CITY OF ALBUQUERQUE

RE: **Blue Linx Warehouse**
1820 Bellamah Ave NW
Grading and Drainage Plan
Engineers Stamp Date 5/26/15 (J13D101)

GRADING PLAN BLUE LINX WAREHOUSE ADAPTIVE RE-USE PROJECT

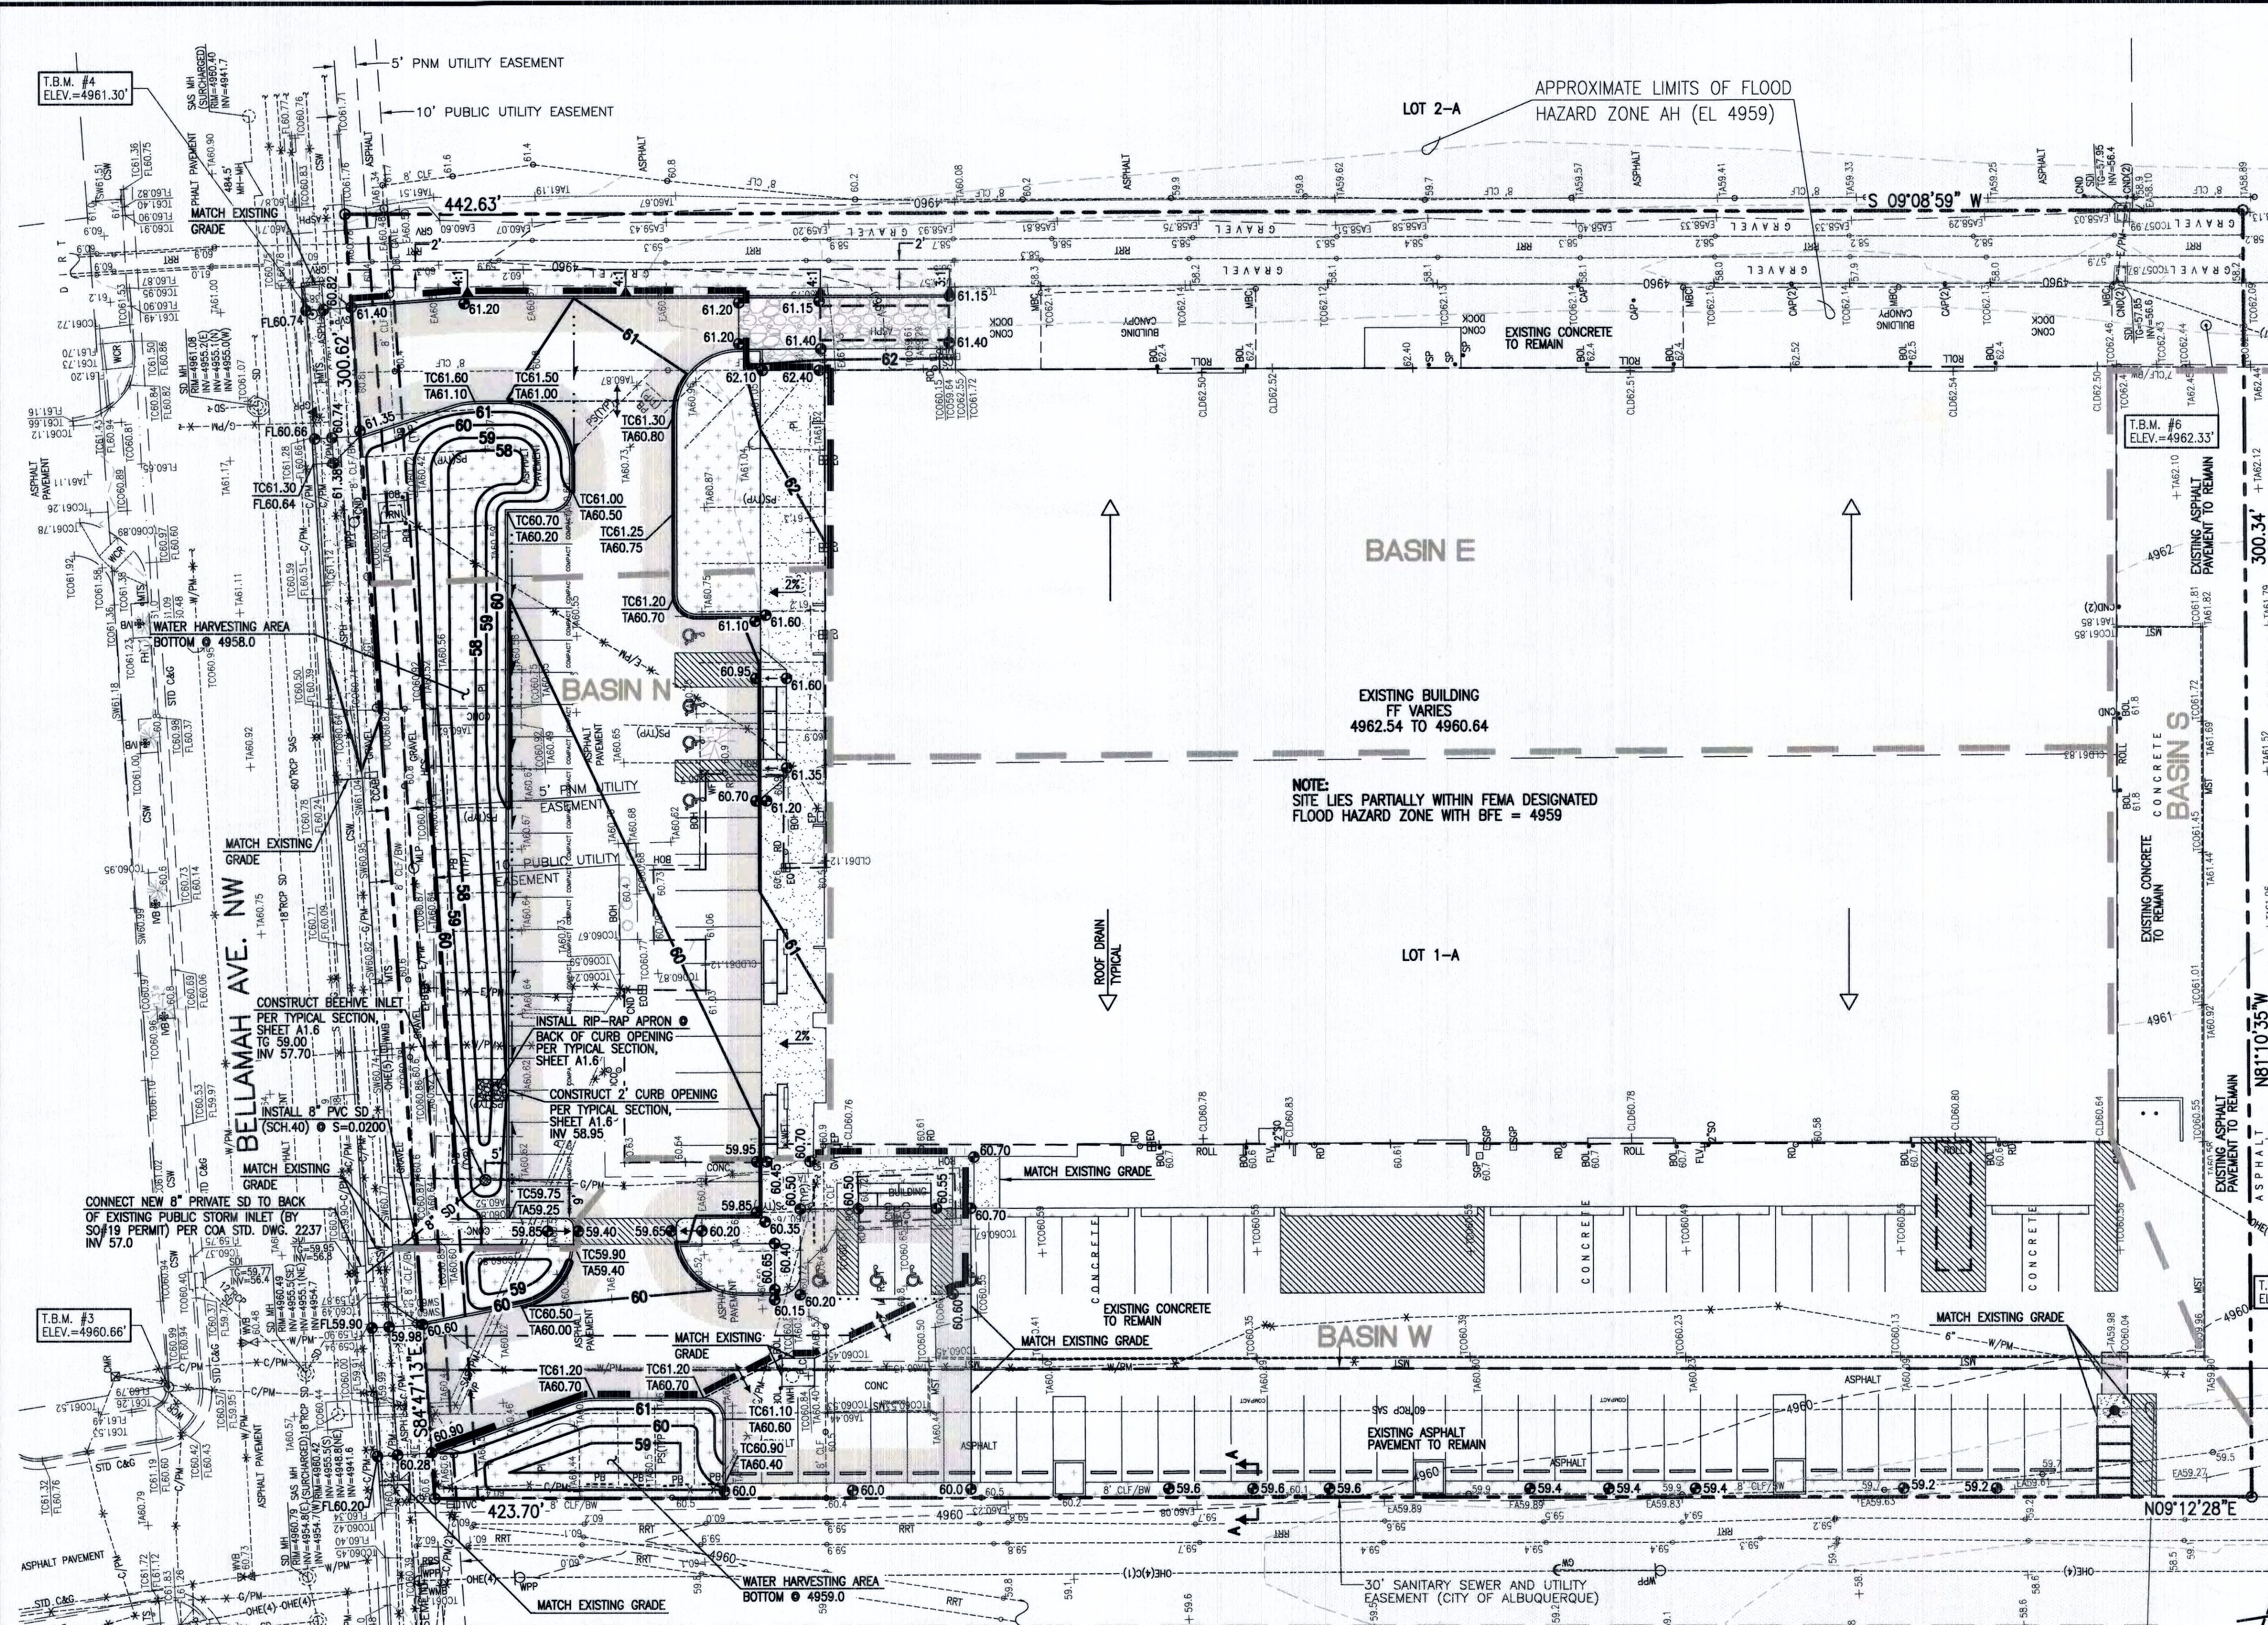
Based upon the information provided in your submittal received 4/20/15, this plan is approved for Building Permit, Paving Permit and SO-19.

Contact Jason Rodriguez at 235-8016 to schedule an inspection for the new 12" storm line connecting into the public storm line. A separate Excavation/Barricading Permit is required for SO-19 construction within City ROW. A copy of this approval letter must be on hand when applying for the permit.
